Re: Comments on Final Supplement to EIS for Vineyard Wind 1 COP, BOEM-2018-0069

Detailed comments

Figure 1
Expected impacts to local tourism of 579' tall wind turbines at varying distances offshore expressed as both % reduction in trips as well as % increases attributable to curiosity seekers

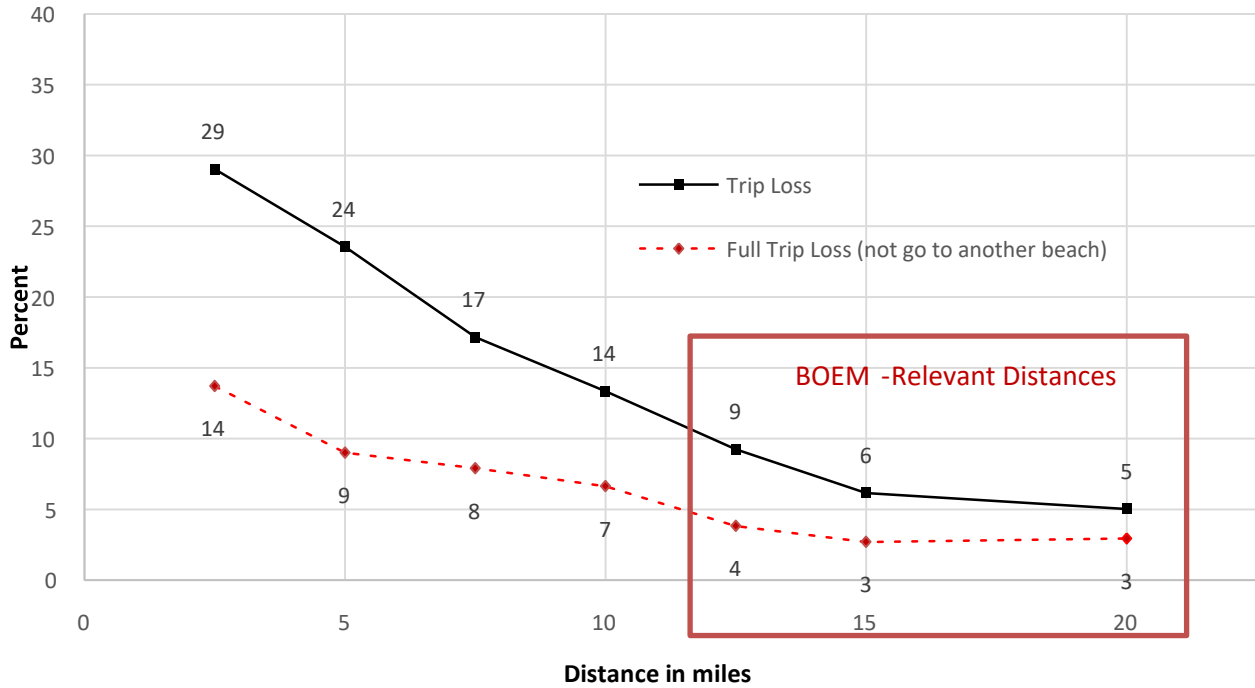
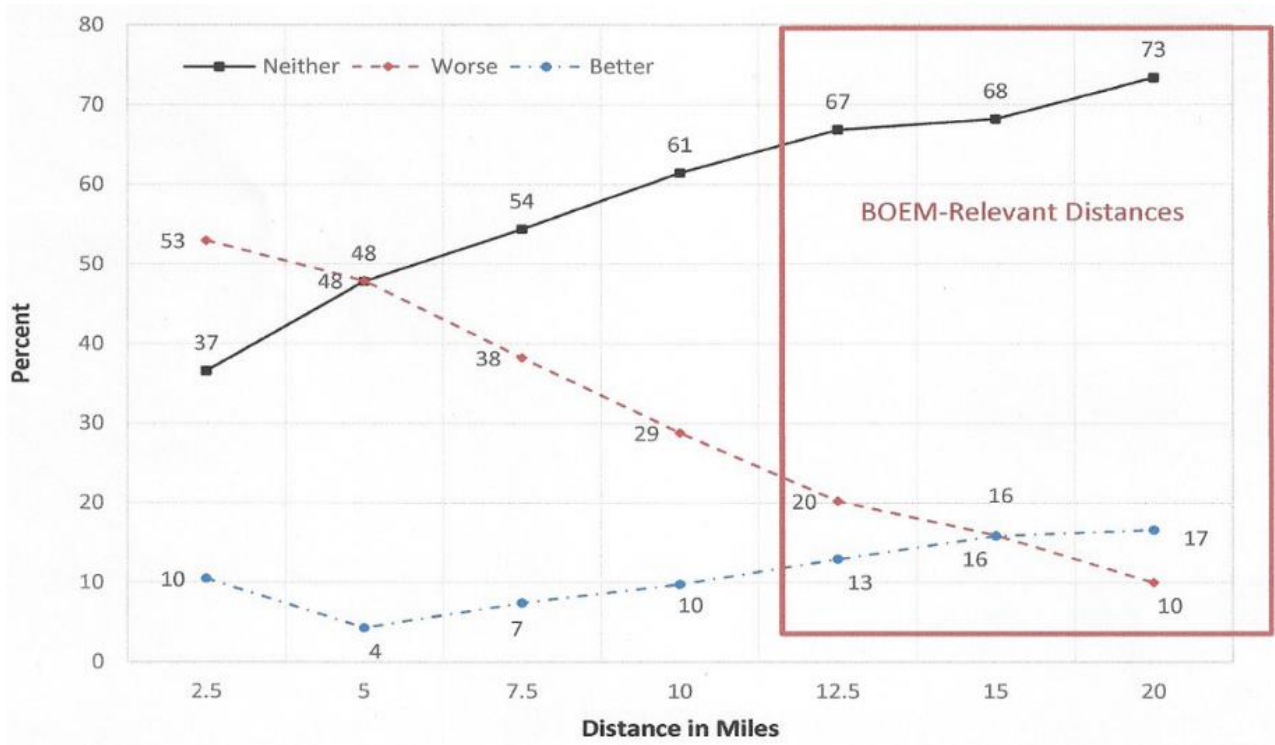
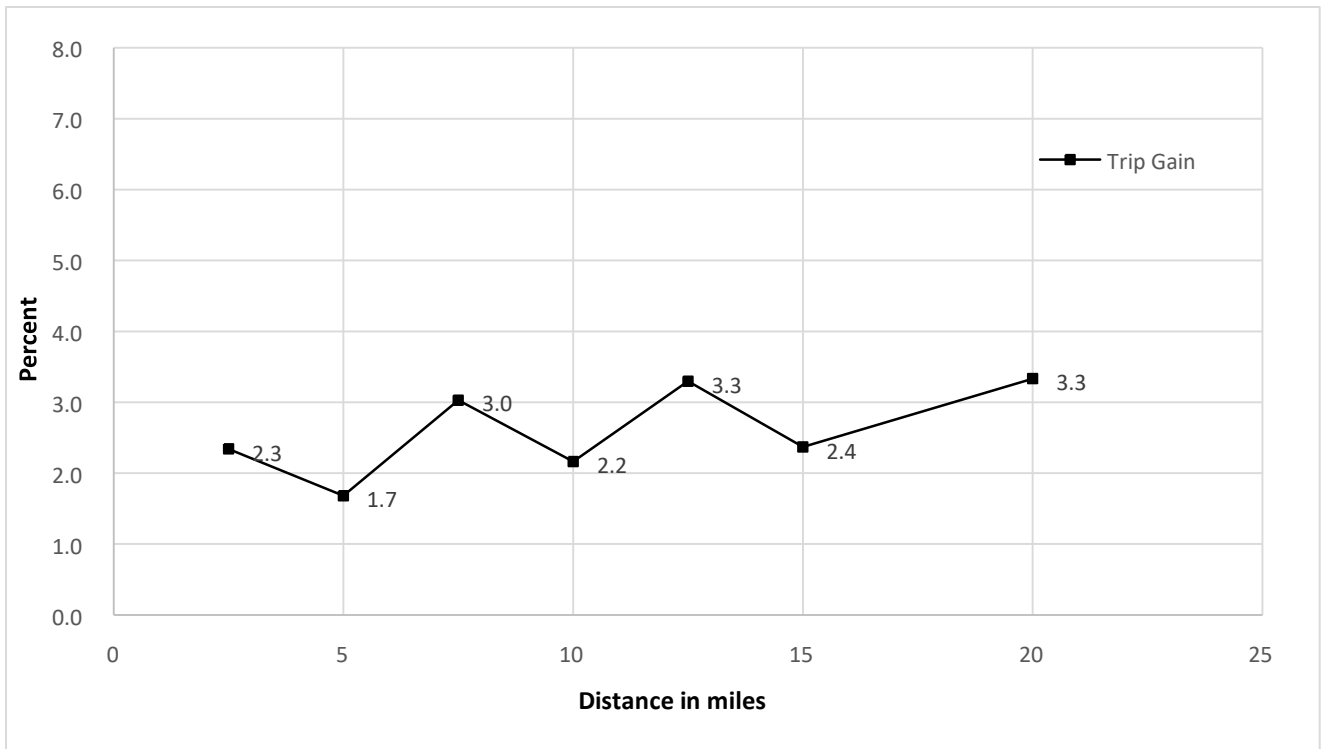
Data charts follow (Figure 1); however, it must be clear that the views/analyses were based on 579' tall turbines which dwarf the revised 853' turbines as now planned. Adjusting for the larger turbines can be satisfied by substituting 14 mile distance data (the closest Vineyard Wind location) with 9.5 mile data meaning 15% of current visitors will not return compared to only a temporary 2% curiosity trip gain. Trip losses at the lease distances range between 6% to 17% adjusting for larger turbines, while gains range between 2.2% and 3.3%, clearly not a “wash” especially considering curiosity trips are single events while losses are essentially permanent. Also, clearly the FEIS finding the number of respondents who thought their trip would be worse (30%) was not about the same as those who thought their trip would be improved (10%) after adjusting for turbine height. The Parsons/Firestone study sample included people involved in beach activities (65%), and people who simply visited the beach area, but not the beach itself (35%) who would not be expected to oppose visible wind turbines so the study results are diluted.
